Inter-Agency Project Update Meeting

NC 143 Improvements

STIP Project No. R-2822B

September 16, 2026, at 3:00 pm
North Carolina Department of Transportation

Figure 5: Hooper Branch Culvert

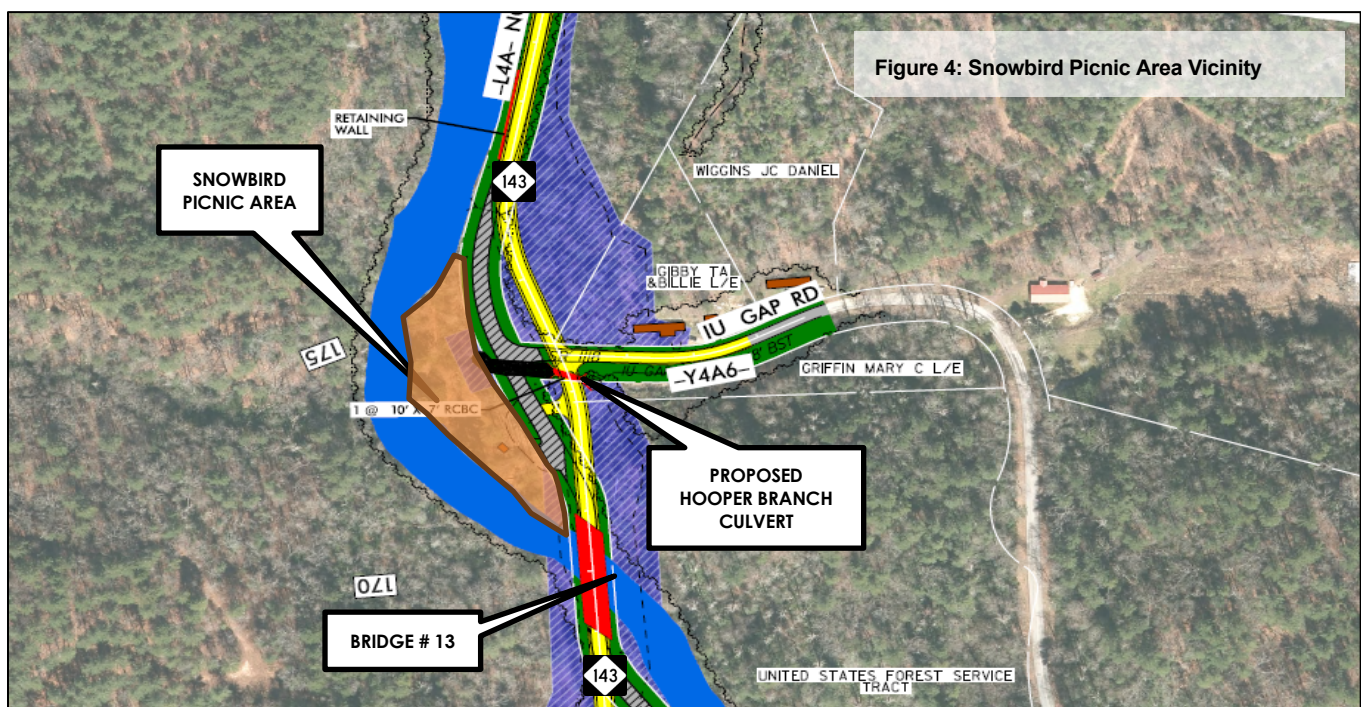
- The US Fish and Wildlife Service (USFWS) and the US Forest Service (USFS) requested a bottomless hydraulic structure be evaluated at the Hooper Branch crossing. NCDOT made the following commitment.
“NCDOT will evaluate the feasibility of a bottomless hydraulic structure at the Hooper Branch crossing. Geotechnical information is required to make a final determination. NCDOT will provide the Merger Team with final hydraulic recommendations once information is available.”

- During the **June 2022 Revisited CP 2A / CP 4B Meeting**, NCDOT advised that geotechnical studies indicated a bottomless culvert would not be feasible due to the depth of bedrock at the site.

- **Aquatic Organism Passage (AOP)**
 - USFS preferred culvert solution
 - AOP design will extend upstream and downstream of the culvert using natural channel substrate, tying into Snowbird Creek and the realigned channel.

- Intent is to lower the culvert's invert about 2 feet rather than widen the structure, pending field investigation. A bypass may be needed for the 100-year flow.

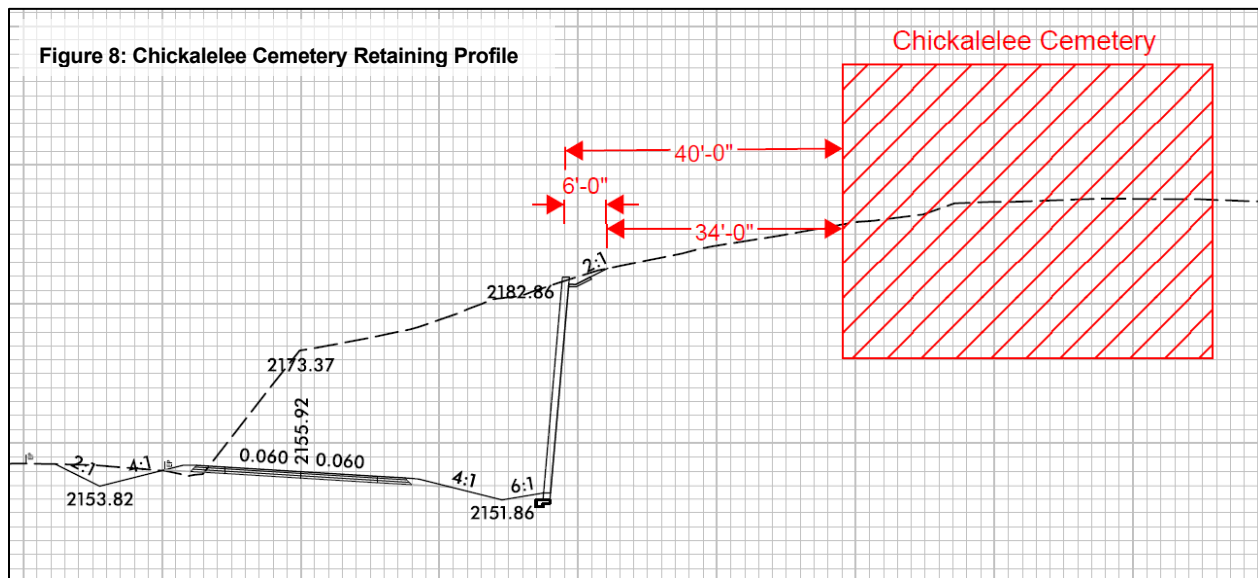
- Staging of construction equipment is restricted at the cemetery site.
- Based on geotechnical studies, the proposed retaining wall will be approximately 360 feet in length with an average height of 20 feet. The maximum height of the wall is 30 feet. This design modification is different from what was included in the *No Adverse Effect* determination. Thus, NCDOT is revisiting the Section 106 Process to provide an opportunity for the THPOs and the NCSHPO to provide comments that can be incorporated into the revised Effects Determination and ultimately, the project through revised environmental commitments (if required) and design elements. **Figure 7** shows the proposed design and wall envelope.

- Per **Figure 8**, the proposed construction of the wall extends 6-feet behind the retaining wall, which fits within a proposed right-of-way measuring 34 feet from the wall. The height of the wall will be increased to 30 feet. However, the wall will not encroach any closer than the measurements that were presented during the **February 2021 Section 106 Effects Meeting**.

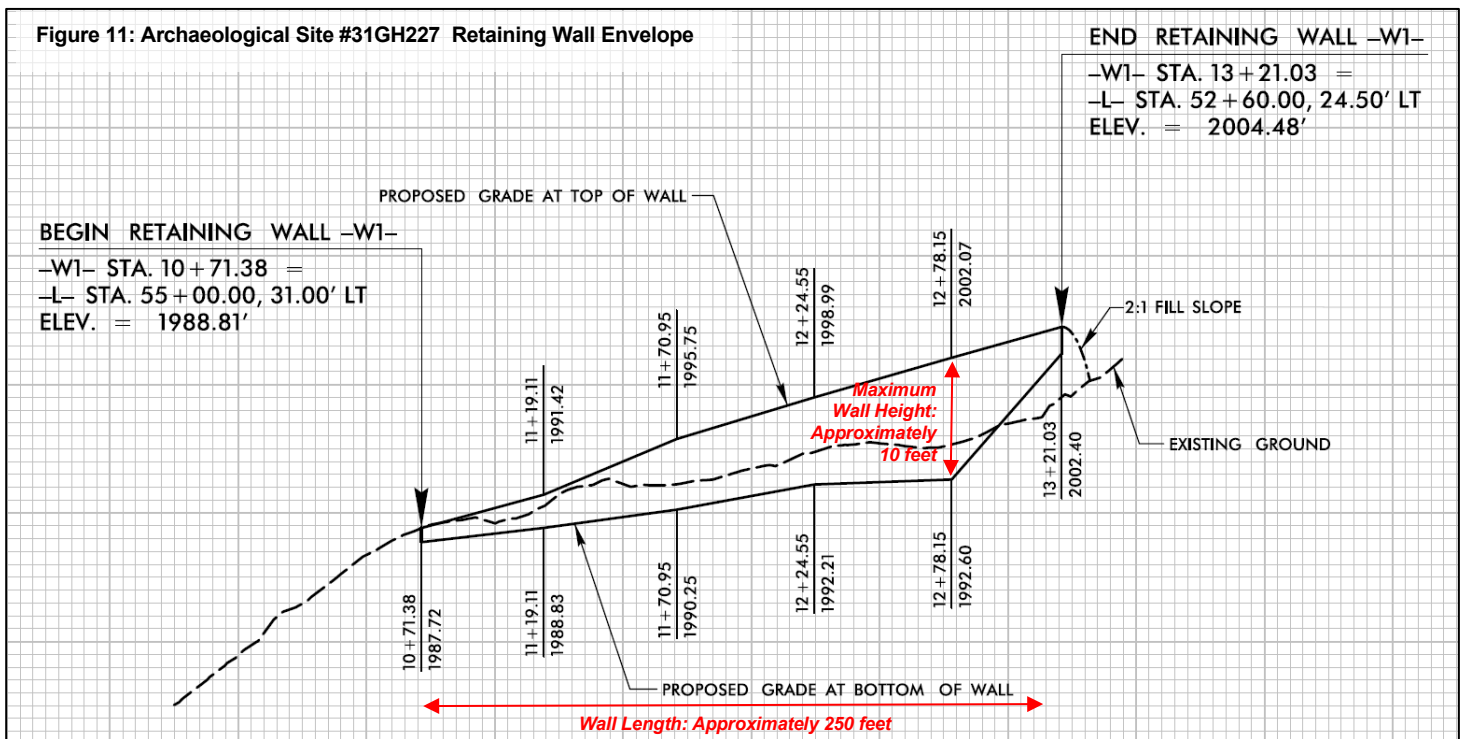
- The proposed project will include a shored Mechanically Stabilized Earth (MSE) retaining wall to avoid this archaeological site. The wall is currently planned to be approximately 250 feet long and averages 5 feet in height. The maximum height of the wall is 10 feet. **Figure 11** shows the proposed design and retaining wall envelope.
- The Archaeological Site will be delineated with an orange safety fence and identified as an Environmentally Sensitive Area in the design plans.

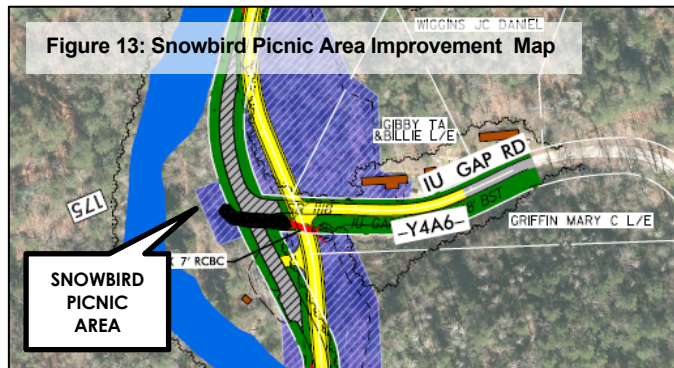
- In 2024, NCDOT was notified of an ESA near the Waste Convenience Site.
- NC 143 will be realigned in the vicinity of the ESA, requiring additional Section 106 coordination and an Effects Determination. Traditional Cultural Property eligibility is pending USACE coordination with the Eastern Band Cherokee Indians (EBCI).
- Coordination required with EBCI and USFS, since the ESA falls on Forest Service land.
